SERVICE BULLETIN

DATE: 23 OCTOBER 2001

FAN PITCH CONTROL AFT TUBE ASSEMBLY ONE TIME INSPECTION

Figure 1. Fan Pitch Control Linkage

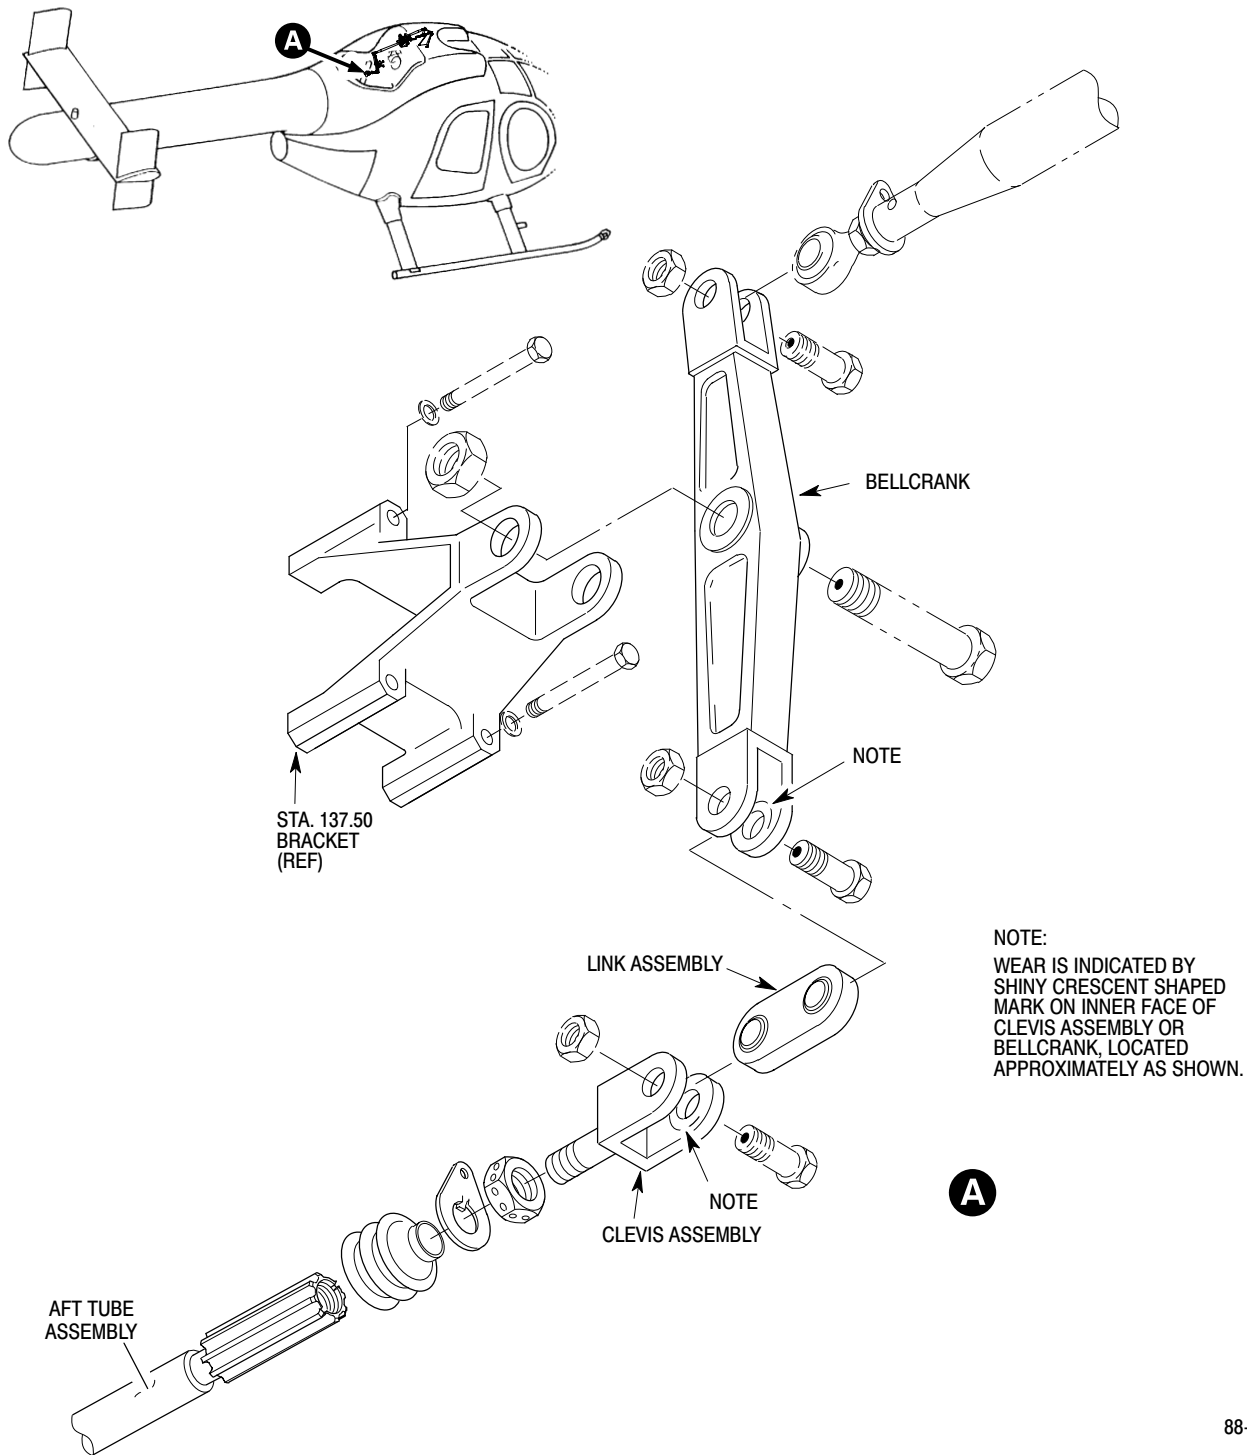
- (2). Inspect link assembly for contact with clevis assembly and bellcrank.
- (3). Inspect inside of clevis assembly and bellcrank for wear, indicated by shiny crescent shaped area near link assembly.

- (4). If link assembly is contacting either clevis assembly or bellcrank, replace aft tube assembly (Ref. CSP-HMI-2, Section 67-20-30, Fan Pitch Control Tube Replacement). Return removed aft tube assembly to MDHI.
- (5). If wear is observed on clevis assembly or bellcrank, replace aft tube assembly, clevis assembly and bellcrank (Ref. CSP-HMI-2, Section 67-20-30, Fan Pitch Control Tube Replacement and Station 135.50 Support Bracket and Bellcrank Replacement). Return removed aft tube assembly, clevis assembly and bellcrank to MDHI.
- (6). Install engine inlet screen (Ref. CSP-HMI-2, Section 71-10-00, Engine Air Inlet Screen Installation (600N) or install particle separator Ref. CSP-HMI-2, Section 71-10-60, Particle Separator Installation).

Figure 2. Splined End of Aft Tube Assembly

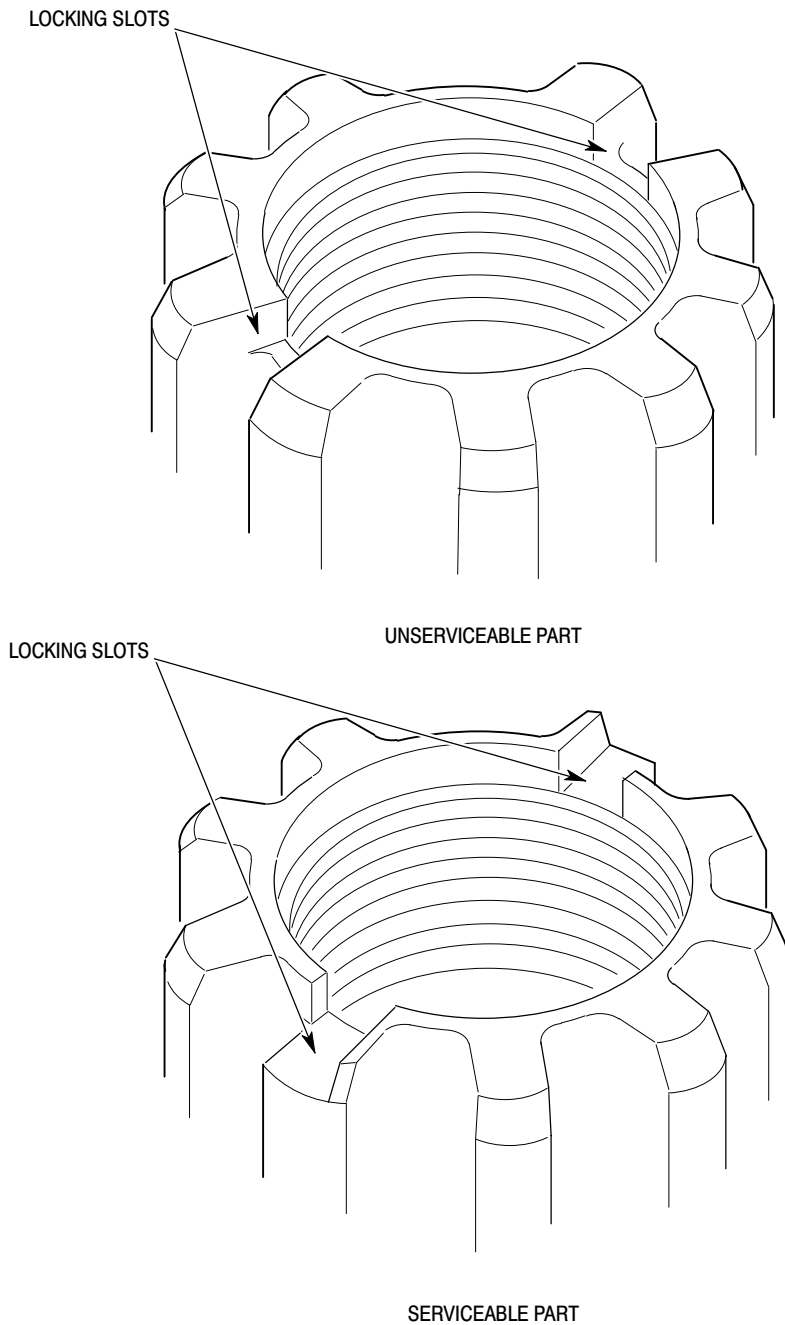
- (1). Inspect splined end of all aft tube assemblies in spares inventory that are marked "Jaco, 1/99".
 - (Ref. Figure 2)
 - (a). An unserviceable part is identified by the locating slot cut between the splines, as shown.
 - (b). A serviceable part is identified by the locating slot cut into part of the spline, as shown.
 - (2). Return unserviceable parts to MDHI.
